# Technical Bulletin

Model(s)	Year	Eng. Code	Trans. Code	VIN Range From	VIN Range To
Jetta (A5)	2006, 2007	BRM	All	All	All

10 07 02 June 29, 2007 2015162

### Engine Compartment, Noises

## Production Solution

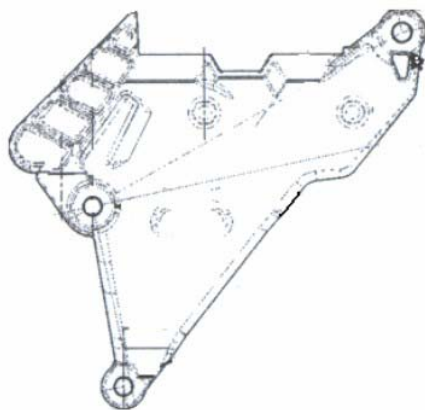
Under certain driving conditions engine support mount bolts may loosen and cause engine compartment noises. Engine block fracture may occur.

Engine block should not be replaced in the case of fracture. New engine support utilizes different mounting location.

New support Part No. 03G199207G, cover Part No. 045109147A and mounting bolts Part No. -2- N10683301, and -1- N10655802.

## Tightening Sequence

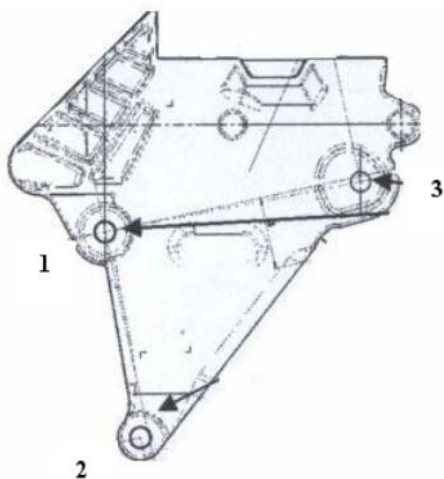
Tighten support bolts as follows:

- Torque 40 Nm + twice 90° in the sequence 1, 2, 3
- Alternatively 40 Nm + 180°

New bolts must be used.
